WSDOT Meeting Minutes

DATE:	September 21, 2021	TIME:	2:30 PM to 4:00 PM
JOB NO.:	315032	PROJECT:	Warren Avenue Bridge Pedestrian Improvements Project
SUBJECT:	Kickoff Meeting	LOCATION:	ZOOM

DATE: December 14, 2021 **TIME:** 10:00 AM to 11:00 AM
JOB NO.: **PROJECT:** Warren Avenue Bridge Pedestrian Improvements Project
SUBJECT: WSDOT Bridge Meeting **LOCATION:** MS Teams

DATE: January 6, 2022 **TIME:** 1:00 PM to 2:00 PM
JOB NO.: **PROJECT:** Warren Avenue Bridge Pedestrian Improvements Project
SUBJECT: WSDOT Traffic Meeting #2 **LOCATION:** MS Teams

Job: 11_2022_01.dwg
 User: scj
 Date: 1/11/2022 10:51:59 AM
 Path: C:\Users\scj\OneDrive\Documents\Projects\Warren Ave Bridge\Drawings\0702_XS-01.dwg

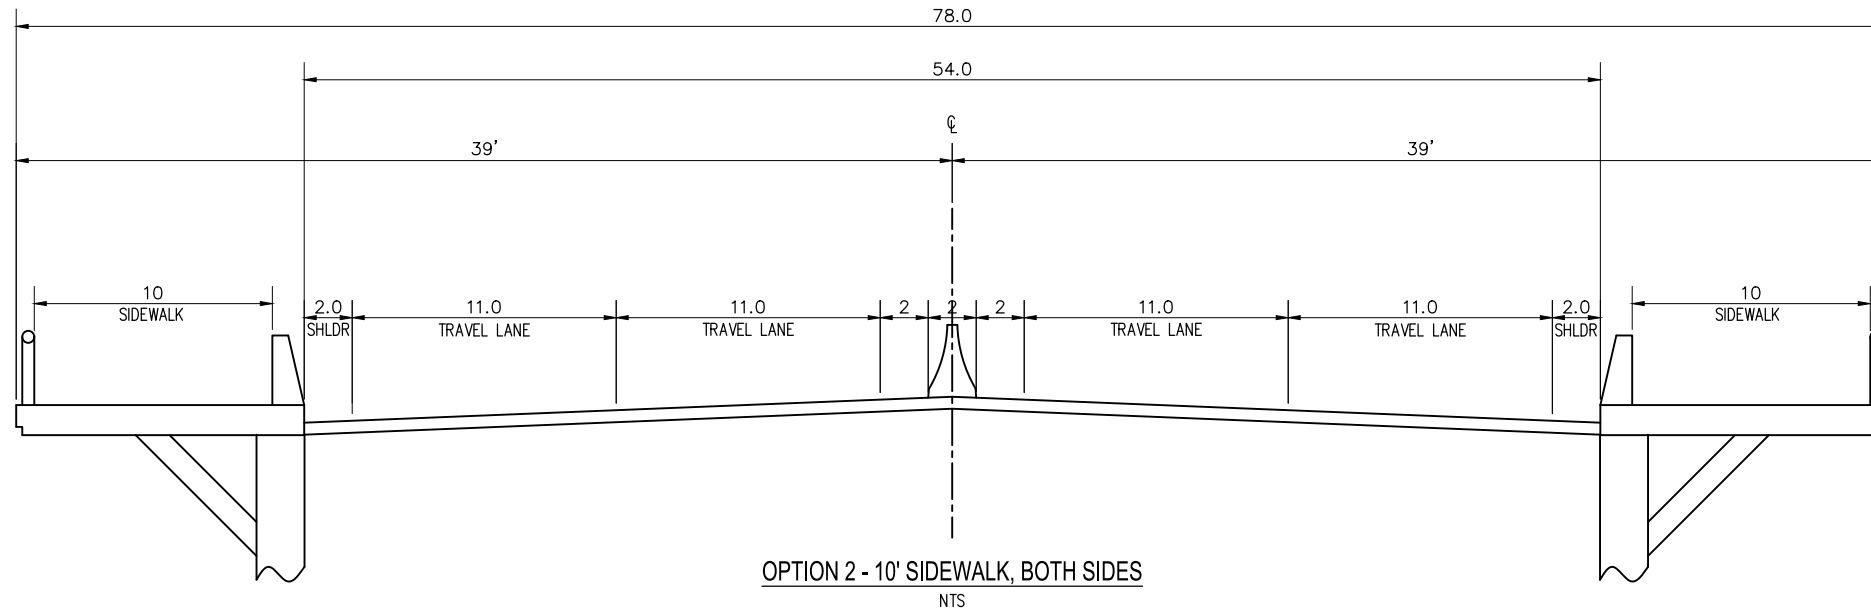
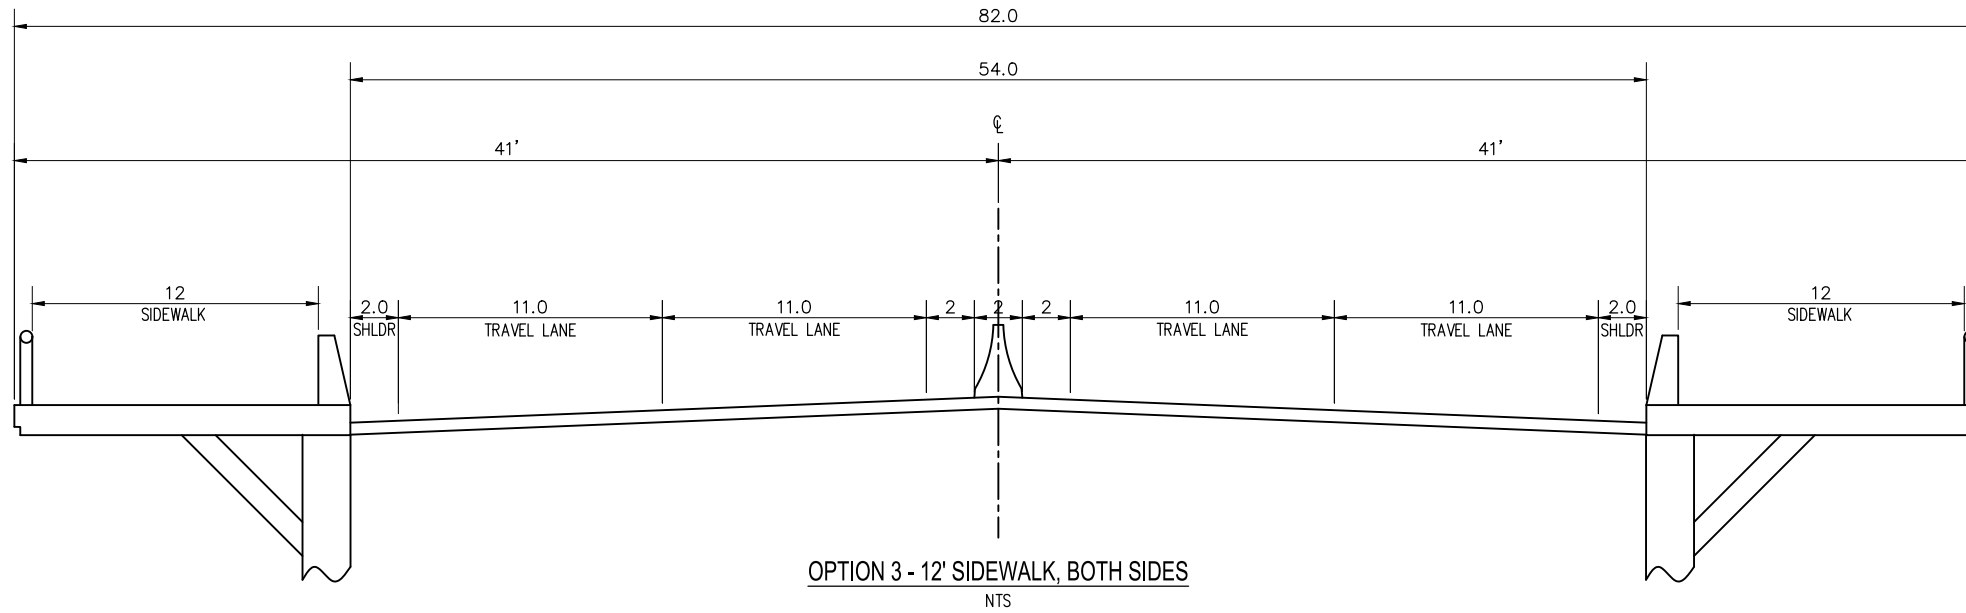
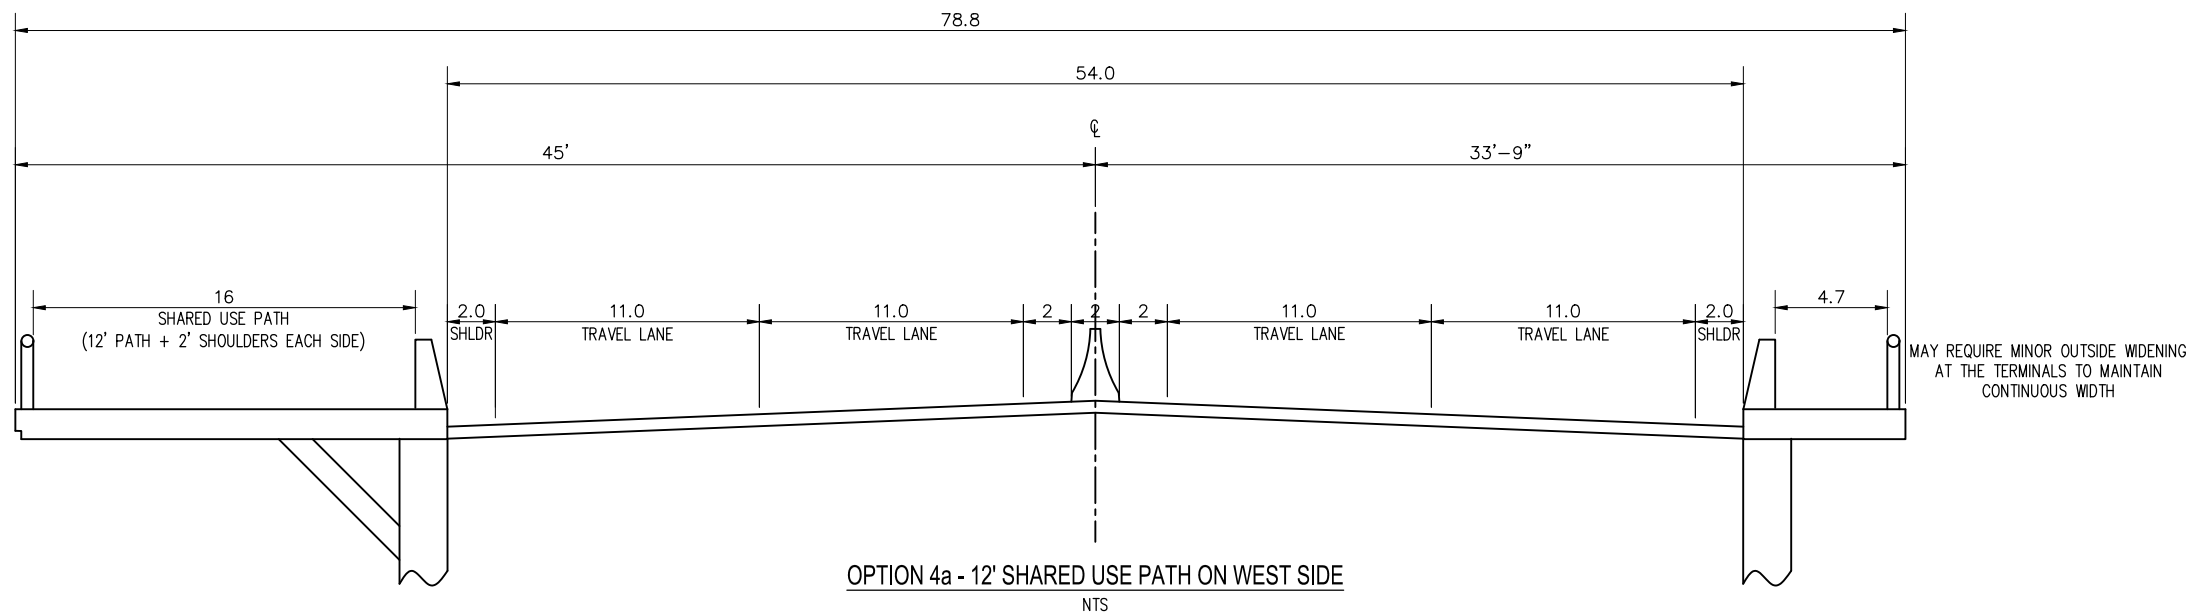
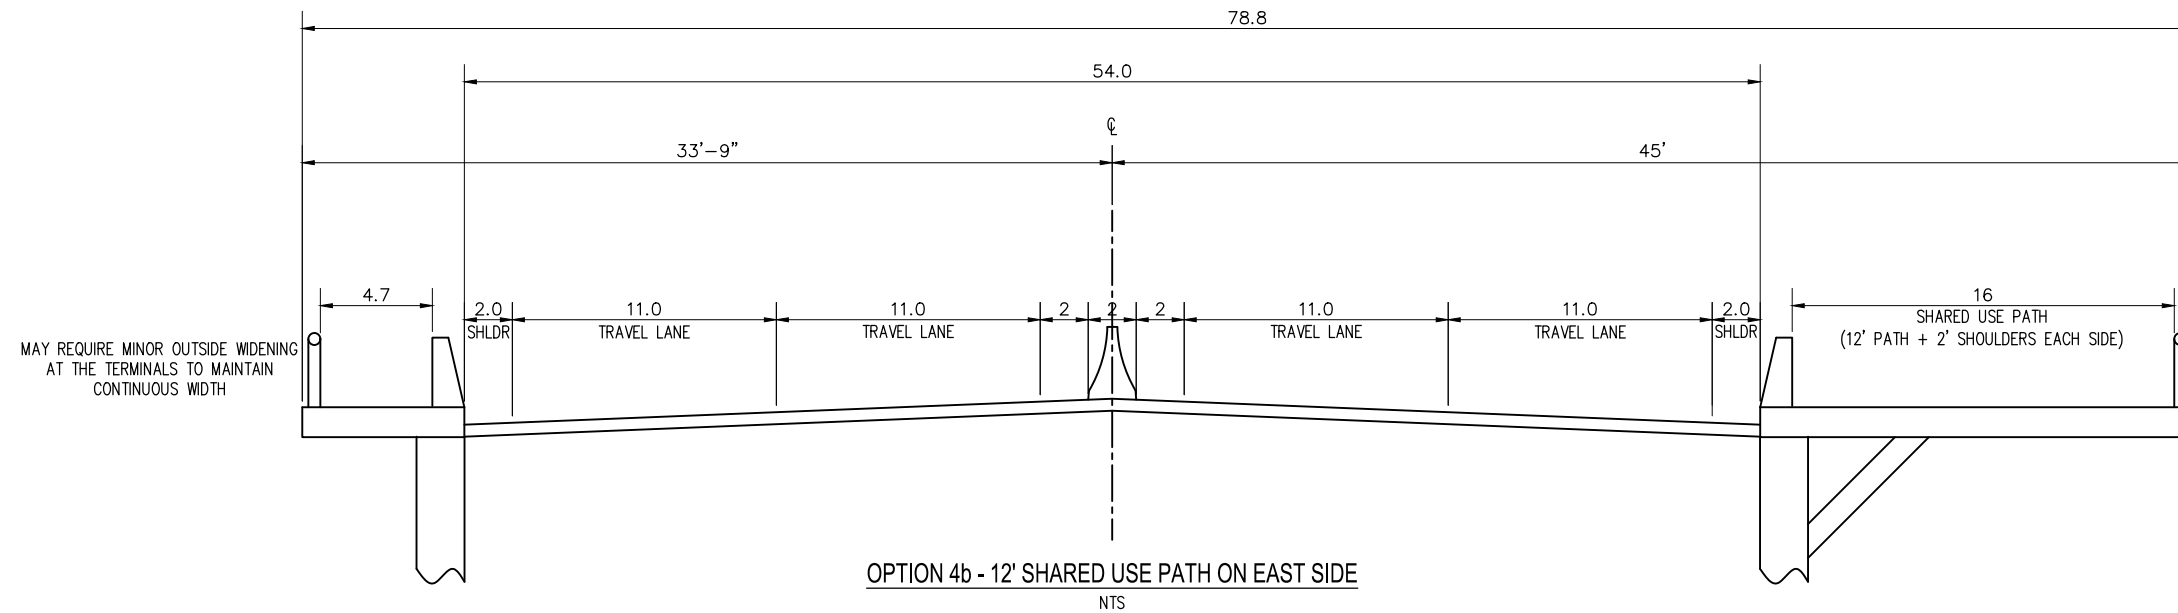
- Traffic barrier addition to the center of the bridge will require a design analysis for a shy distance less than 4'. Lesser shy distances have been used elsewhere in the state network.

- Shy distance concern based on deflecting barrier into opposing traffic
 - Consider lane width/utilization since folks will shy away from the barrier
 - Melissa suggested that 2' could be justifiable

- Barrier deflection for standard barrier is 2'
 - For comparison, Aurora Ave Bridge did not have any curbing at the time.
- Outside shoulder width DM of 2' – 8'

- Standard for location with barrier would be 4' shoulder. Design analysis would be required to go less than 4'.
- Bridge widening (Sarah)
 - Could we do two different widths on east/west sides?

- 11' lanes seem appropriate.
 - Could use 2' shoulder for traveled way and try to achieve 14' barrier to barrier on SUP. Additional 1' to path is more valuable than 1' of additional road shoulder.

- Aaron to update sections and send to Sarah ASAP
